Product Change Notice (PCN)

件名: RH850/F1K シリーズの生産拠点の追加および材料変更

発行日: 12/9/2024

マーク印字例 : R7F7015834AFP-C#BA3 (F1K 144pin)

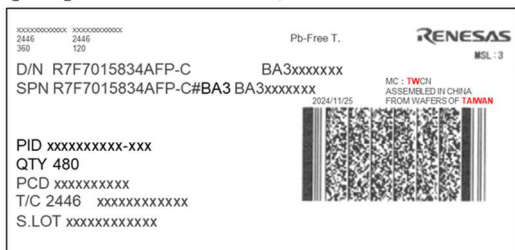
那珂品は赤文字部分が異なります。(TSMC品 : T, 那珂品 : N)

また錦品はトレースコードの桁数(青文字部分)が異なります。(蘇州品 : 7桁, 錦品 : 9桁)

R7F7015834AFP-C#BA3 (F1K 144pin)

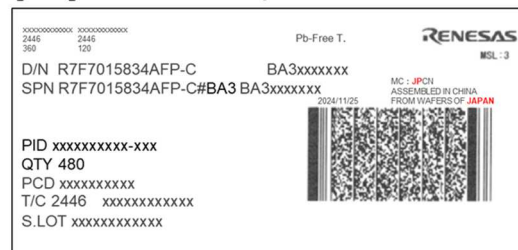
那珂品は赤文字部分が異なります。また錦品は青文字部分が異なります。

[追加] WP : 那珂、組立/FT : 蘇州

[追加] WP : 那珂、組立/FT : 錦
